TECHNICAL SERVICE BULLETIN

Technical Service Bulletin: 03-1240

Make(s): SIERRA & SANDPIPER
Model(s): MANY
Model Year(s): 2019 - 2020

Concern:
The installed control panel may allow the slide-rooms to retract without operator command.

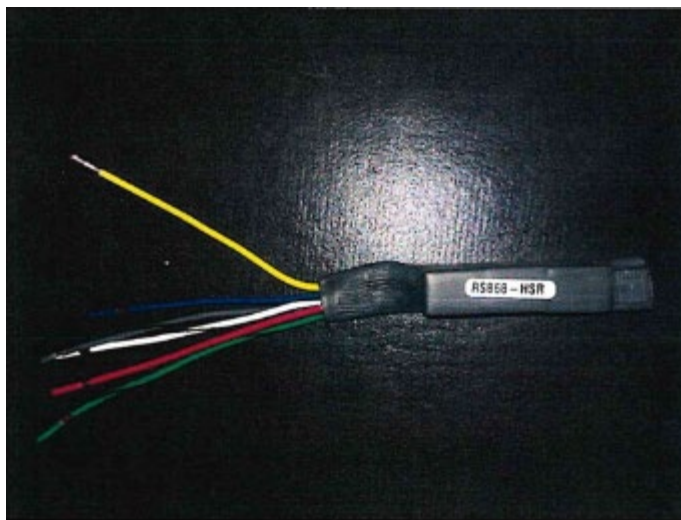
The HSR red wire wired goes to hot, and the HSD red wired goes to the one tang on the Valve Magnet for Hydraulic Slides. So when replacing the HSR with the HSD you will need to remove the red wire on the HSR from the WAGO connector and re-close the WAGO connector.

Next go to the Valve Magnet tang that has ground wires on it, remove the ground wires and secure them as you will not do anything with them.

Run a new 14 gauge white wire from this tang to the red wire on the new HSD.

Important: Leave the orange wire on the other Valve Magnet tang alone.

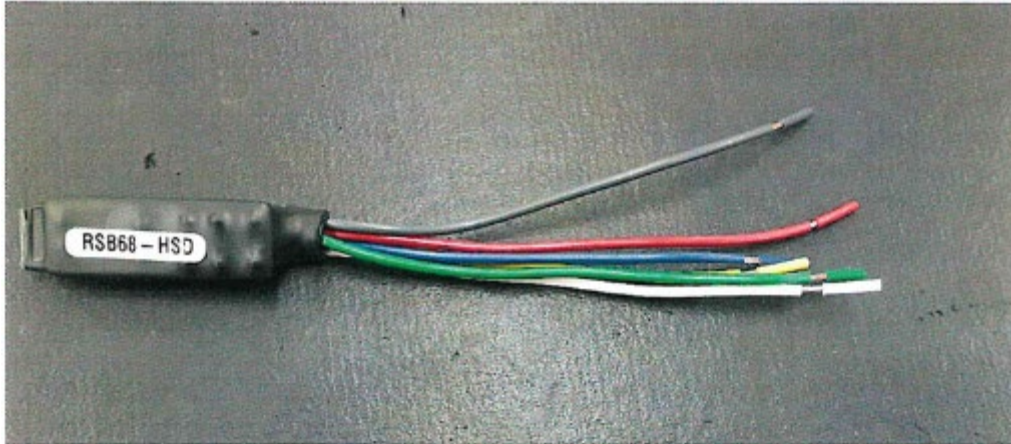
The Green & White wires from the HSR need to be reversed on the HSD. See below for the HSR and the HSD wires breakdown.

The yellow and blue wires on the HSD will connect to the same wires as the HSR was connected to.

RSB68-HSD WIRE	
RSB68-HSD WIRE COLOR	CONNECTS TO:
RED WIRE	OUR WHITE 14 GA. WIRE THAT GOES TO ONE OF THE TANGS ON THE VALVE MAGNET FOR HYDRAULIC SLIDES.
GREEN W/ WHITE STRIPE	OUR WHITE 14 GAUGE ZIP WIRE THAT GOES TO THE FWD TANK ON THE TROMBETTA.
BLUE WIRE	MAIN ROOM OUT + (POS.) WHITE WIRE ON PLUG 1
GREY W/ BLACK STRIPE	OUR ORANGE 12 GA. WIRE GOING TO THE VALVE MAGNET FOR HYDRAULIC SLIDES.
WHITE W/ BLACK STRIPE	OUR BLACK W/ WHITE STRIPE 14 GA. ZIP WIRE ABOVE WHICH GOES TO THE REV. TANK ON THE TROMBETTA.
YELLOW WIRE	MAIN ROOM - (NEG.) ORANGE WIRE ON PLUG 1
